**Amendments to the Drawings**

U.S. Serial No. 10/593,374  
Page 6 of 9

[Fig. 2]

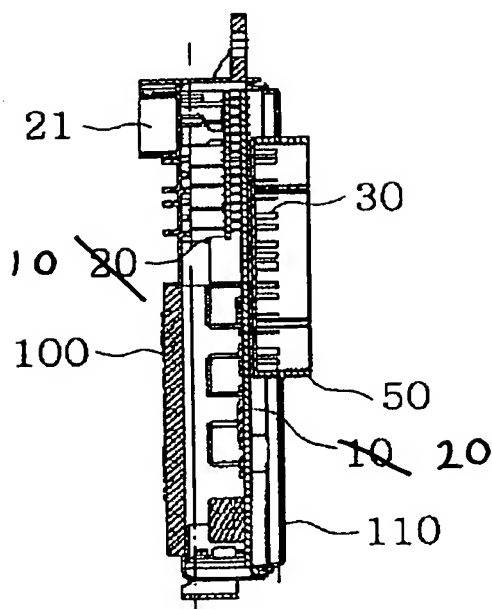
Figure 2 previously had the upper PCB 10 and lower PCB 20 labels switched. The corrections are shown in the following Annotated Sheet. This was an unintentional error and the correct configuration is described in the specification and is shown in Figure 1. This alteration correctly represents the disclosed invention.

For the final version of the corrected diagram, please see the Replacement Sheet that is appended to this transmittal.
